Re: Carlsbad Energy Center Project (07-AFC-6)
Correspondence to San Diego Regional Water Quality Control Board

**Subject: Response to San Diego RWQCB Comments
Report of Waste Discharge - Carlsbad Energy Center Project's
Proposed Ocean Water Purification System
at Encina Power Station**

1009715-M-SK-003 Rev E
 28 October 2009
 Drawn by A. Schaaf

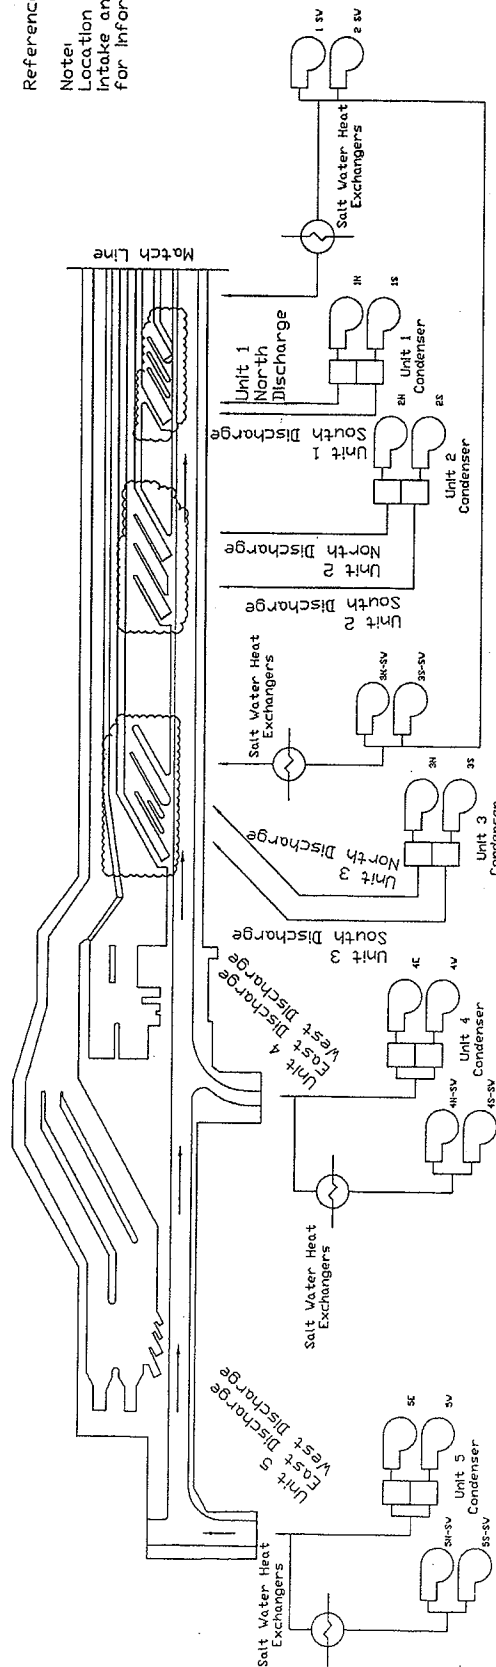
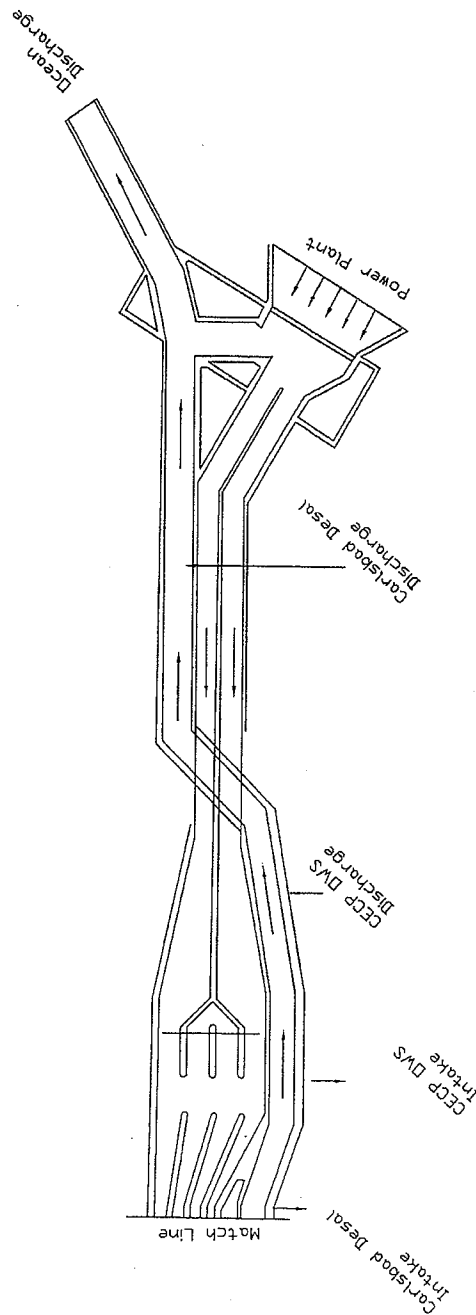
Question: *"Please provide a complete diagram(s) of the discharge channel that clearly shows the location of the intake in relation to Units 1 – 5 and the Carlsbad Desalination Project's proposed intake location under all current and future operational scenarios."*

Question: *"Please provide a diagram that shows precisely where the dilution water intake occurs under all operational circumstances."*

3) **Question:** *"When we last spoke, you mentioned the CECP could be run off the flow from the service pumps. We would like more details on the service pump configuration. Describe in detail what portion of the intake channel is used to provide flows to service pumps (i.e., where is each service pump located?)."*

Response: Attached Diagram 1009715-M-SK-003 shows the general relationships between CECF, EPS Units 4 and 5 that will remain in service, and EPS Units 1 – 3 that will be removed from service after the commissioning of CECF Units 6 and 7, and the approximate locations of the Carlsbad Desalination Project connections.

Response: Attached Diagram 1009715-M-SK-003 shows the existing unit's service and circulating water pump channel discharge flows.

Response: Attached Diagram 1009715-M-SK-003 identifies the general locations of existing service water pumps and includes a table with the capacity of each pump.

Response: In general and as discussed above in Response 2, based on the design and operations procedures for EPS, at least one of the EPS service water pumps will be operating when EPS Units 4 and 5 are not generating power and thus, their circulating pumps (i.e., large capacity cooling pumps) are not in operation. The smallest service water pumps are rated at 3,000 gpm (or 4.32 MGD) and either one is ample to provide the purified ocean water for the project. One of these pumps operating represents the worse case dilution scenario discussed in our ROWD. The largest service water pumps are rated at approximately 9,000 gpm (or 13.10 MGD) as shown on the attached diagram.
